West Burton Solar Project

Figure 8.18.2: Landscape and Ecology Mitigation and Enhancement Measures West Burton 2

Revision A

Document reference: APPEX1/WB6.4.8.18.2_ A

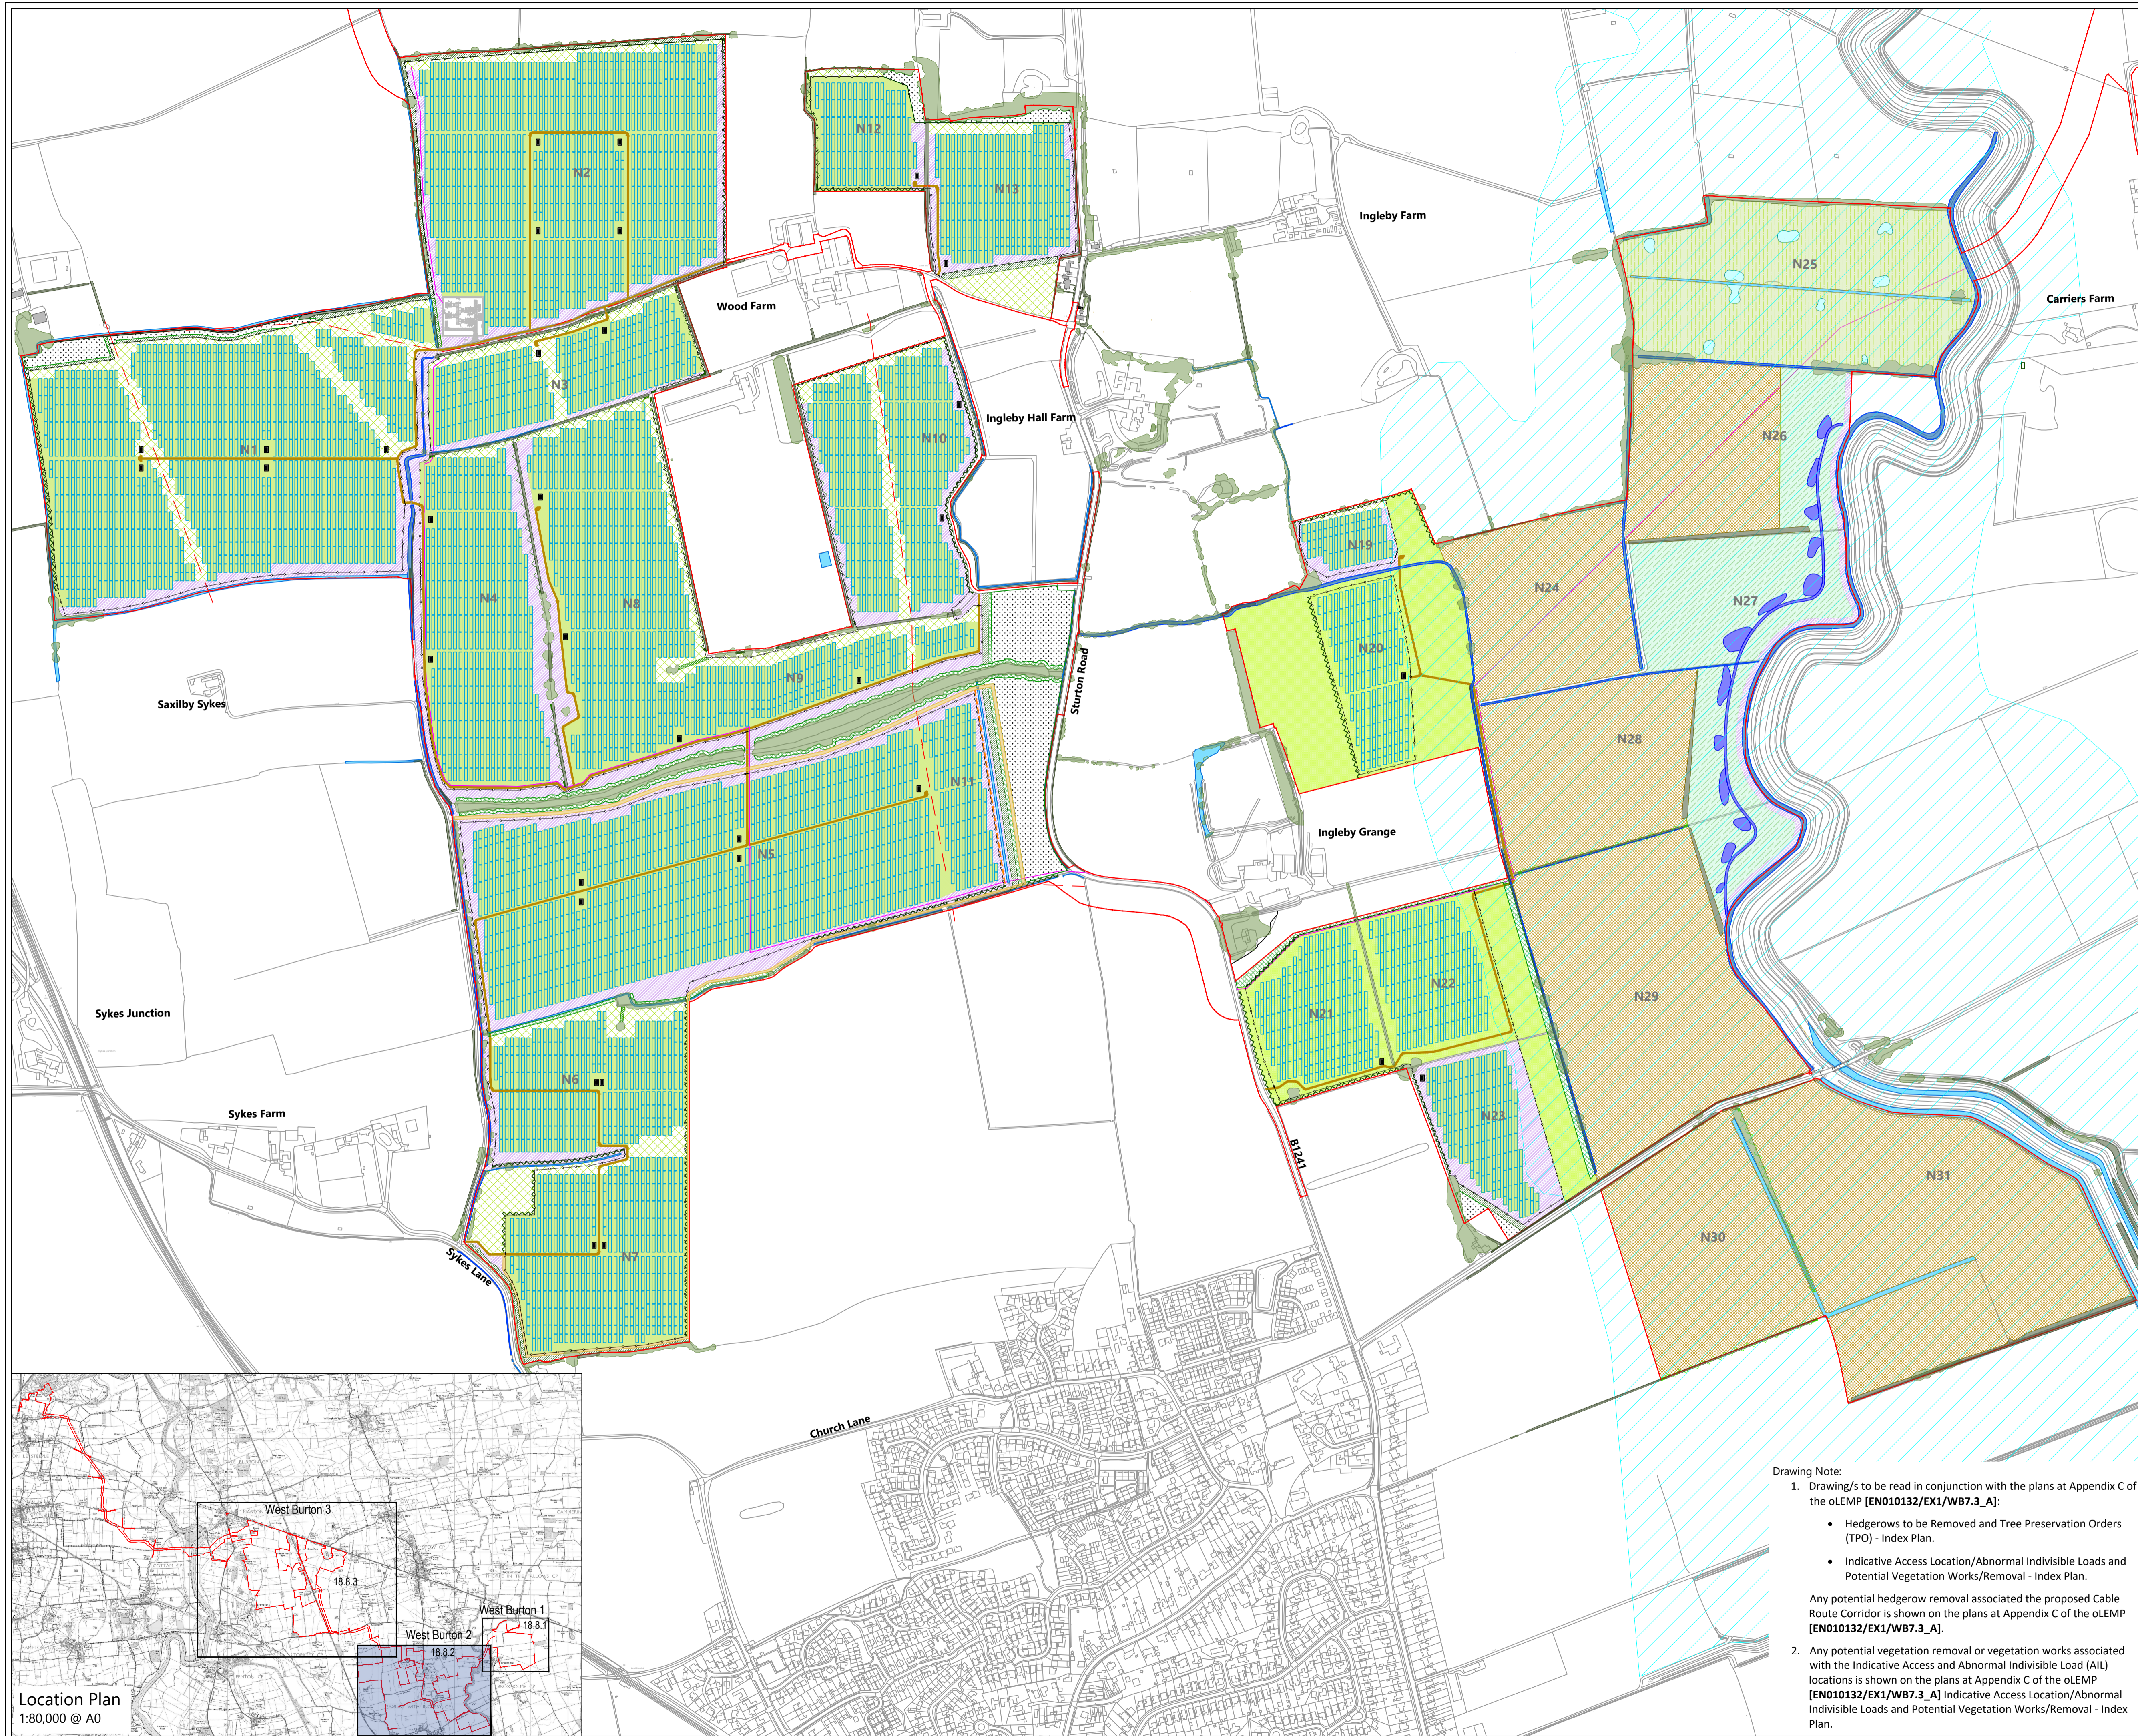
Figure Reference	Page	Description of Changes	Reason for Revision
WB6.4.8.18.2_A	3	<p>Change to spelling of 'enhancement'.</p> <p>Amend the wording of hedgerow removal in the key from 'Existing hedge to be removed' to 'Existing hedge to be removed permanently'.</p> <p>Offset calculations from drains.</p> <p>Changes to hedgerow removal locations.</p> <p>Changes to proposed woodland planting.</p>	<p>To correct a typo.</p> <p>For clarity.</p> <p>For clarity.s</p> <p>For clarity.</p> <p>In response to changes to proposed cable route and tracks</p>
